TRANS/WP.29/GRE/2002/20
28 January 2002

World Forum for Harmonization of Vehicle Regulations (WP.29)

PROPOSAL FOR DRAFT AMENDMENTS TO REGULATION No. 48

Transmitted by the Expert from the Working Party "Brussels 1952" (GTB)

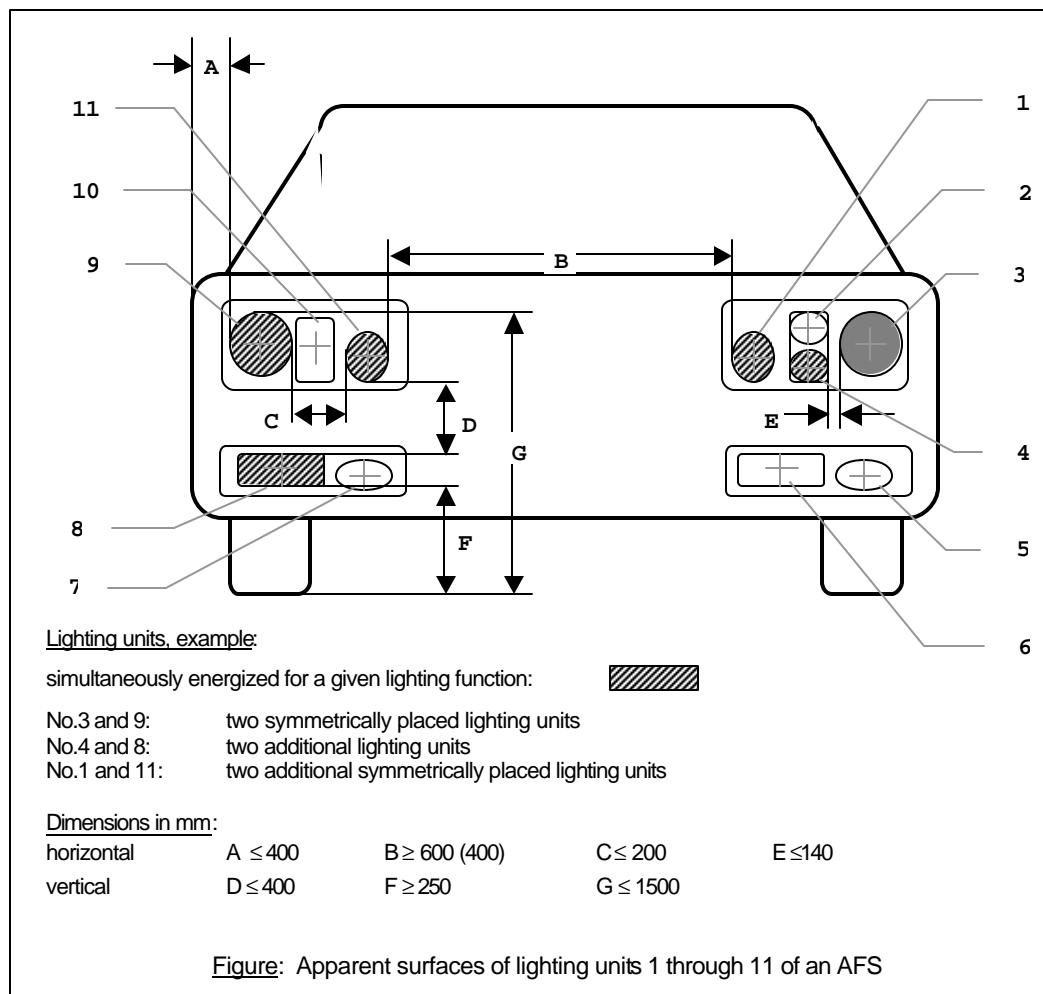
6.20.4.1.2. Additional lighting units, if any, on either side of the vehicle shall be positioned at a distance not exceeding 140 mm ^{7/} in horizontal direction (E in the figure) and 400 mm in vertical direction above or below (D in the figure) from the nearest lighting unit;

6.20.4.1.3. None of the additional lighting units described in paragraph 6.20.4.1.2. above shall be positioned lower than 250 mm (F in the figure) nor higher than 1,500 mm (G in the figure) above the ground;

the outer edge of the apparent surface of at least one lighting unit on each side of the vehicle shall not be more than 400 mm from the extreme outer edge of the vehicle (A in the figure); and,

the distance between the inner edges of the apparent surfaces of the lighting units on the right and left hand side of the vehicle

^{7/} In case of additional "two symmetrically placed lighting units" the horizontal distance may be 200 mm (CC in the figure).

(B in the figure) shall be not less than 600 mm, or, except for category M₁ and N₁ vehicles not less than 400 mm when the overall width of the vehicle is less than 1,300 mm.
